Product Information

Roto Patio Inline | SR: Assembly jig espagnolette position in the wing

Roto Patio Inline

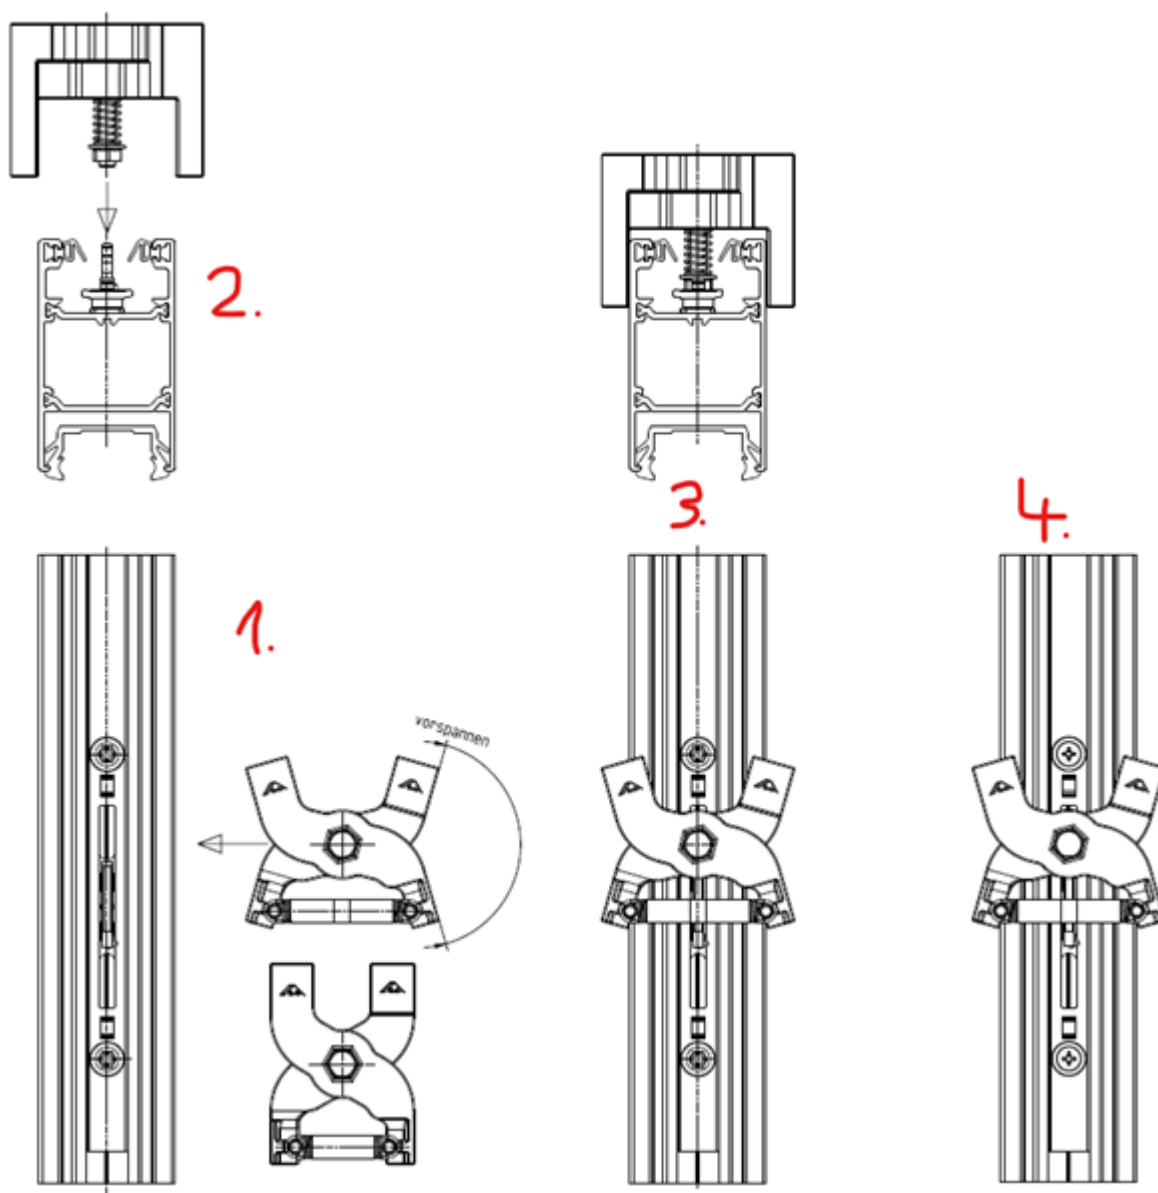
With the jig, the standard and reverse espagnolettes can be mounted
easier in a sash with a smooth rebate. Implementation via PA 2025/2508.

The jig must be preloaded (see Figure 1). It is then placed over the profile
and espagnolette (see Figures 2 and 3), with one jig at the top and one at
the bottom of the espagnolette (screw of jig in the slotted hole above the
hook). This holds the espagnolette in the correct position in the profile. In

the final step (see Figure 4), the espagnolette need to be screwed into place and then remove the jig.

All standard and reverse espagnolettes (not compact espagnolette). Two assembly jigs are always required per one espagnolette.

New article for jig: 2049784
